Office Action Summary	Application No. 10/664,371	Applicant(s) ORBAY, JORGE L.	
	Examiner Anu Ramana	Art Unit 3775

DETAILED ACTION

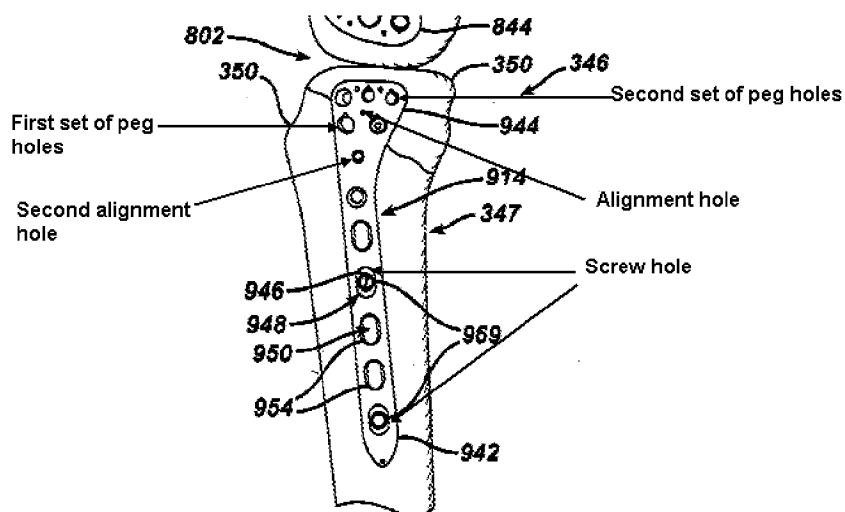
Wack et al. disclose a plate 914 defining a first set of peg holes structurally adapted to engage a threaded head of a fixation peg and at least one non-threaded alignment hole or k-wire hole sized to receive a k-wire, the alignment hole having a second small diameter relatively smaller than each of the peg holes in the first and second sets (Figs. 20-22 and paras [0118]-[0162]). See a portion of Fig. 20 marked up to show features of Applicant's invention below.

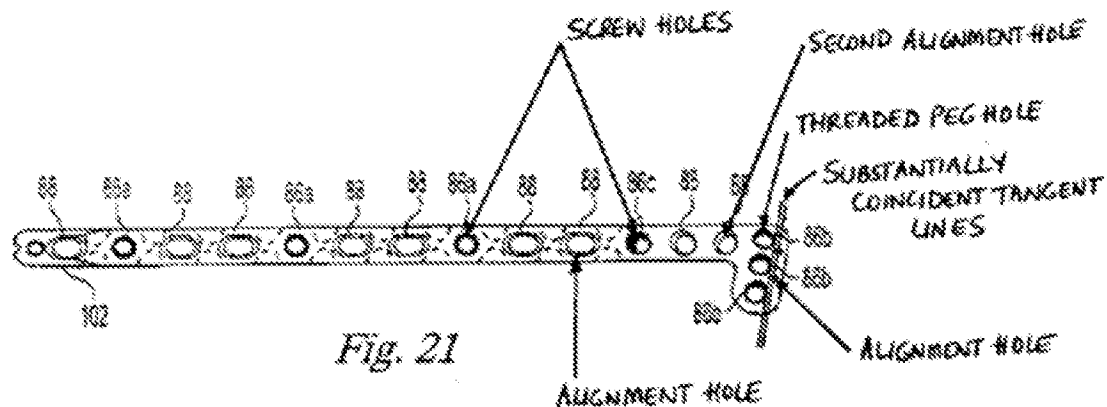
Weaver et al. disclose a bone fixation plate 80 including: a head angled relative to a the shaft; the head portion defining a first set of threaded holes 86b; alignment holes much smaller in diameter than the threaded holes for provisional fixation of the bone plate; a second alignment hole 88; and a plurality of screw holes 86a in the shaft of the bone plate (Figs. 20-26, col. 6, lines 58-67 and col. 7, lines 1-17). See marked up Fig. 21 from Weaver et al. on the following page.

Weaver discloses all elements of the claimed invention except for an alignment hole located entirely between two immediately adjacent peg holes.
